Access Compliance Report

Public Rights-of-Way

(Curb Ramps)

Intersection ID: 13197	Main Street: S_MCDOWELL_ST	Cross Street: E_4TH_ST	Location: E
ADA ID: 12123E5A7FEA	Ramp Type: Perp	Initial Pass/Fail: Fail	Overall Compliance: No
Severity Score: 33.75			
Codes/Mitigation Info/Possible Solution		Field Measurements/Component Compliance

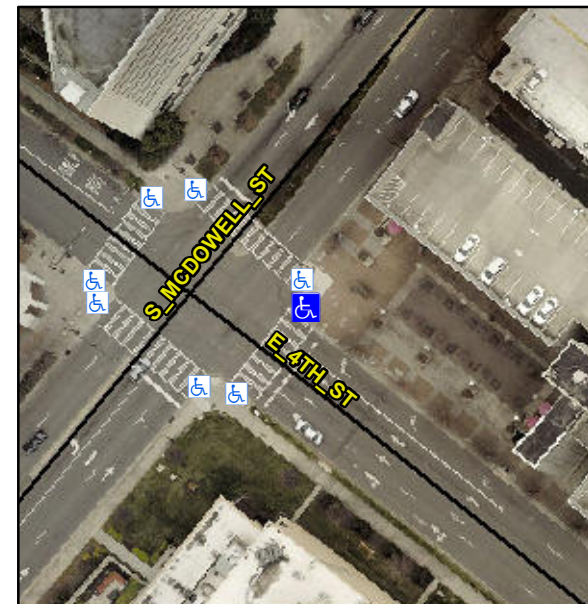
Not Found, R304.5.1, R304.2.2, R304.5.3

Compliance	Description	Data	Compliance	Description	Data
N/A	Ramp Length (in)	60.0	No	Ramp Slope (%)	10.9
No	Ramp Width (in)	46.5	No	Ramp XSlope (%)	6.5
N/A	Flare Type LT	N/A	N/A	Flare Type RT	N/A
N/A	Flare Slope LT (%)	N/A	N/A	Flare Slope RT (%)	N/A
N/A	Flare Traversable LT?	N/A	N/A	Flare Traversable RT?	N/A
N/A	Landing Length (in)	N/A	N/A	DWS Provided?	N/A
N/A	Landing Width (in)	N/A	N/A	DWS Contrast?	N/A
N/A	Landing Slope (%)	N/A	N/A	DWS Length (in)	N/A
N/A	Landing X Slope (%)	N/A	N/A	DWS Full Width?	N/A
N/A	Landing Curb? (Y/N)	N/A	N/A	DWS Offset (in)	N/A
N/A	Shared Landing?	N/A			
N/A	Gutter Ponding?	N/A	N/A	Gutter Slope (%)	N/A
N/A	Gutter Lip Ht (in)	N/A	N/A	Gutter X Slope (%)	N/A
N/A	Painted X Walk1?	Yes	N/A	Painted X Walk2?	N/A
	X Walk 1 Direction	To SW		X Walk 2 Direction	N/A
N/A	X Walk 1 Width (in)	181.0	N/A	X Walk 2 Width (in)	N/A
	X Walk 1 Slope (%)	2.2		X Walk 2 Slope (%)	N/A
	X Walk 1 X Slope (%)	4.4		X Walk 2 X Slope (%)	N/A

Remove & Replace Entire Ramp.
